DOUGLAS COUNTY
COLORADO

Preliminary Plan Staff Report

Subject: **Bloom Preliminary Plan**

Project File: **SB2025-017**

Figure 8

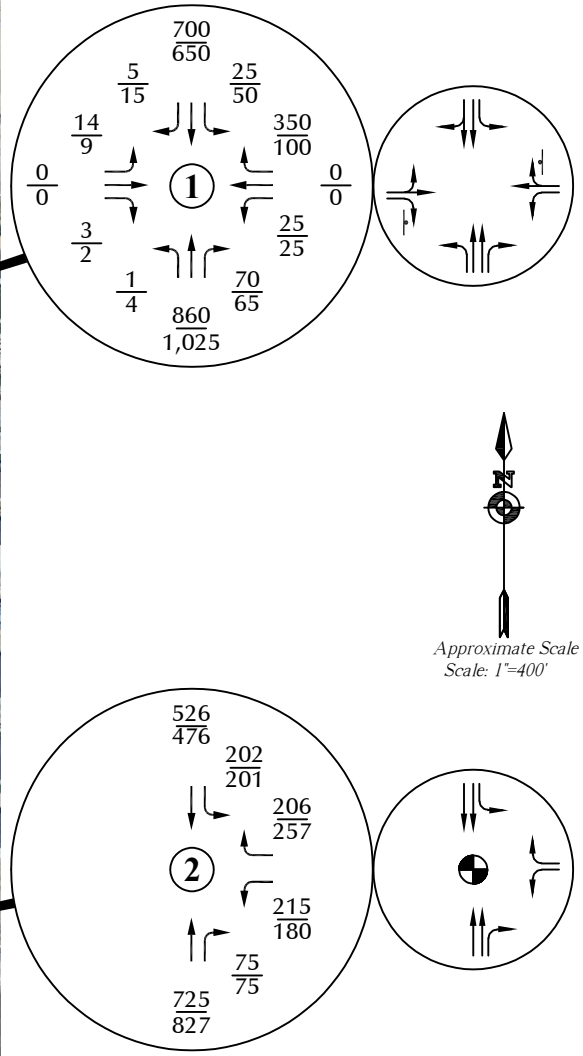
Per Figure 9 (2045), there is no change in the volume on the site's connection to Bayou Gulch Rd compared to the volume shown in Figure 8 (2028) . The study should indicate what is expected to change, volume wise, with the future roadway connection to the property to the west.

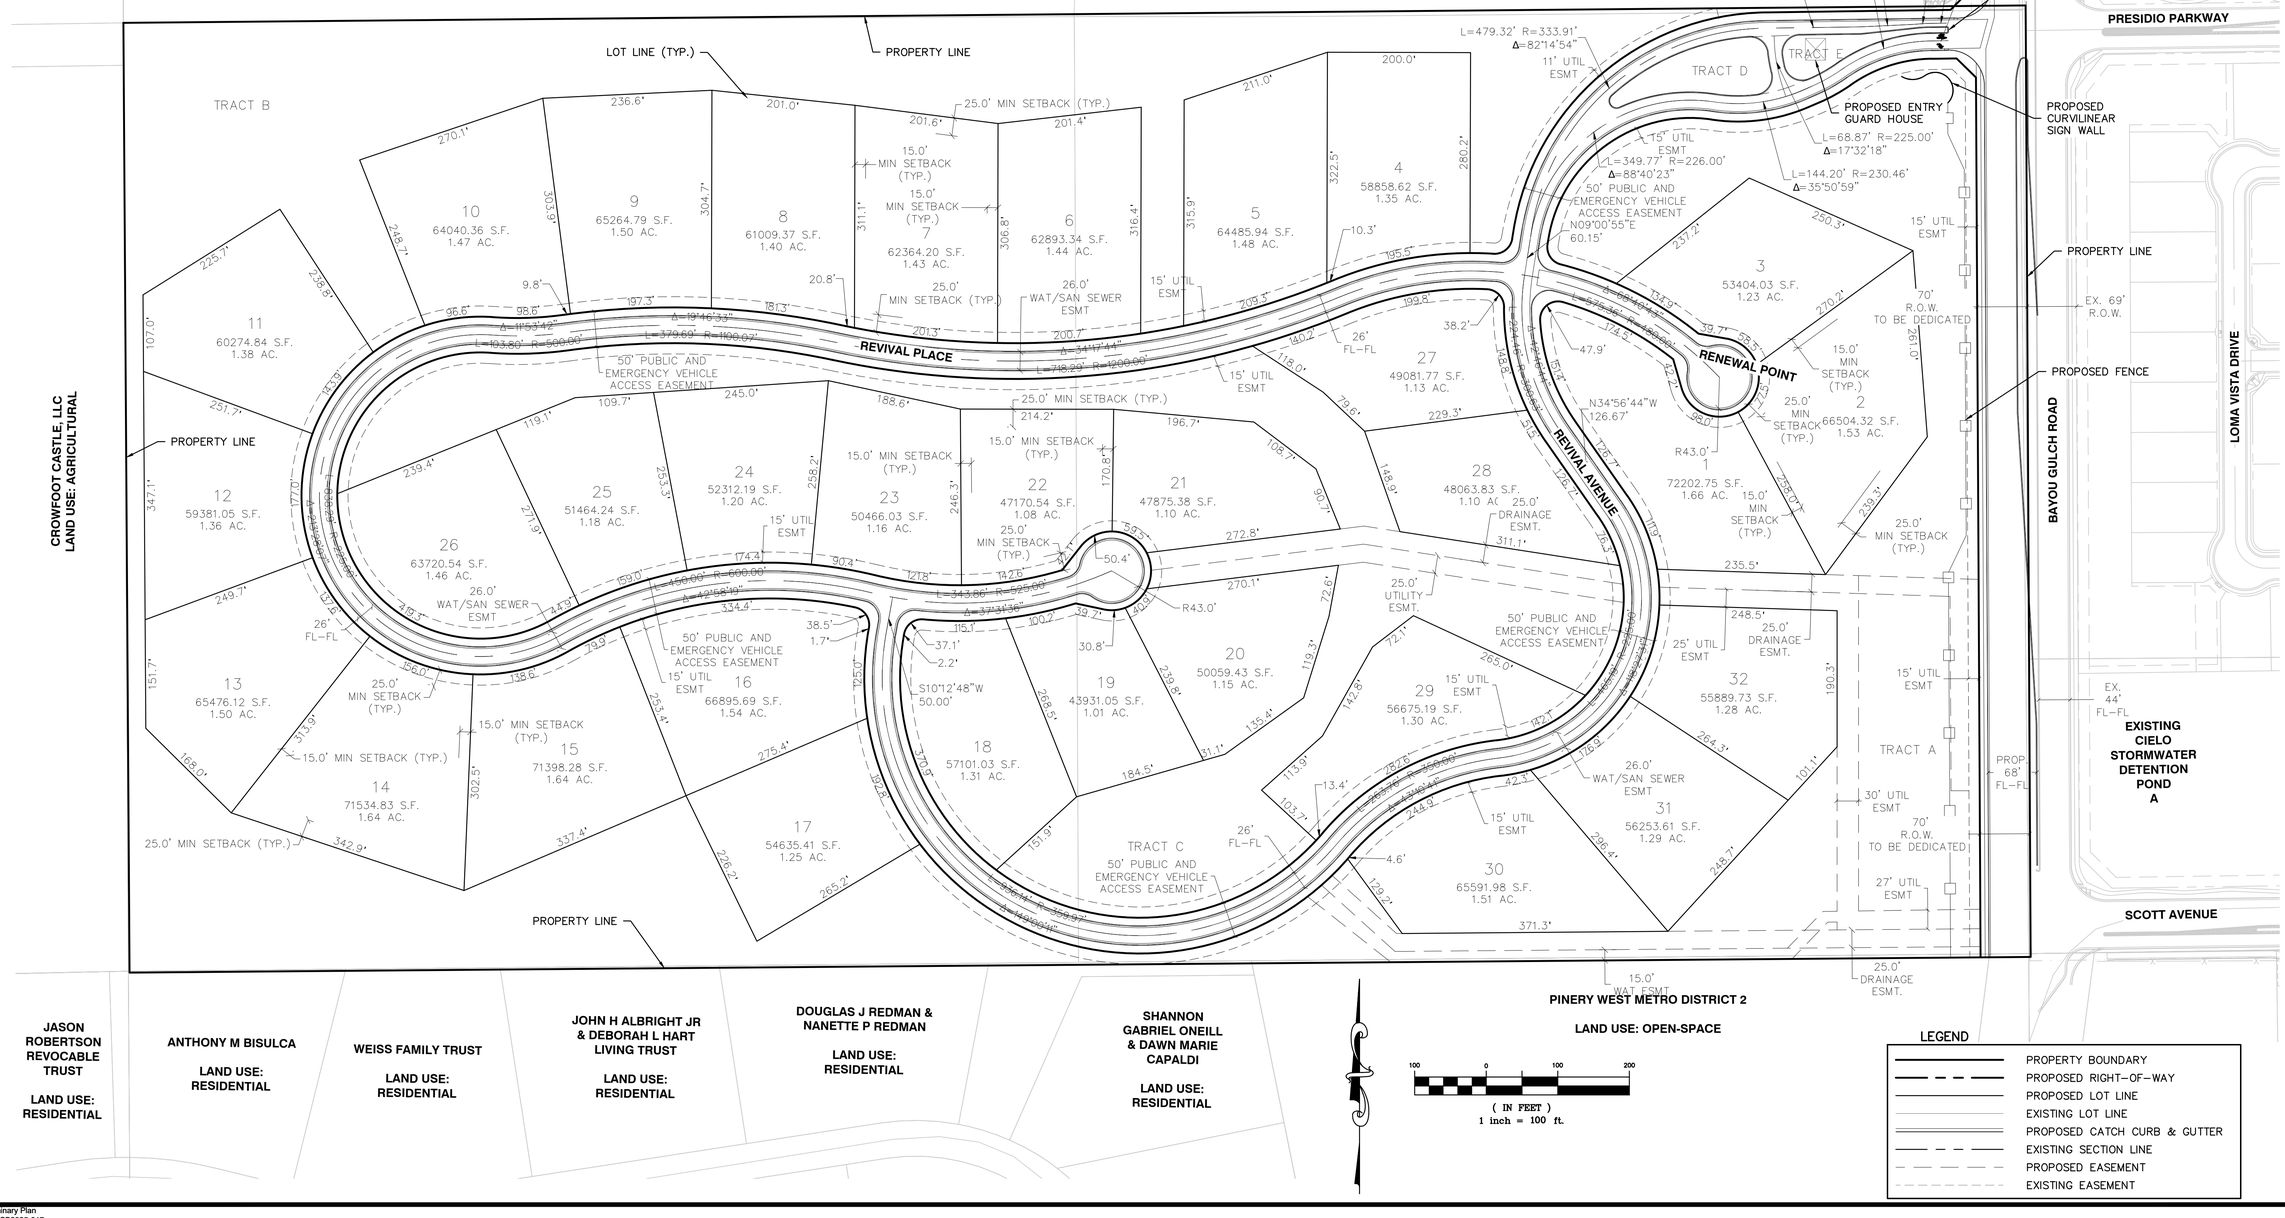
RESPONSE: *Sprinkler systems will not be required and the note has been removed from the Preliminary Plan.*
15. In the Tract Area table on sheet 2, the HOA is listed for ownership and maintenance of the proposed tracts but Note 8 on the cover sheet states that it will be the Bloom Metro District, please clarify.

RESPONSE: *Tract F is proposed for the private roads and utility easements.*
21. On sheet 2 in the Land Use Table, please provide the square footage and percentage of open space area provided.
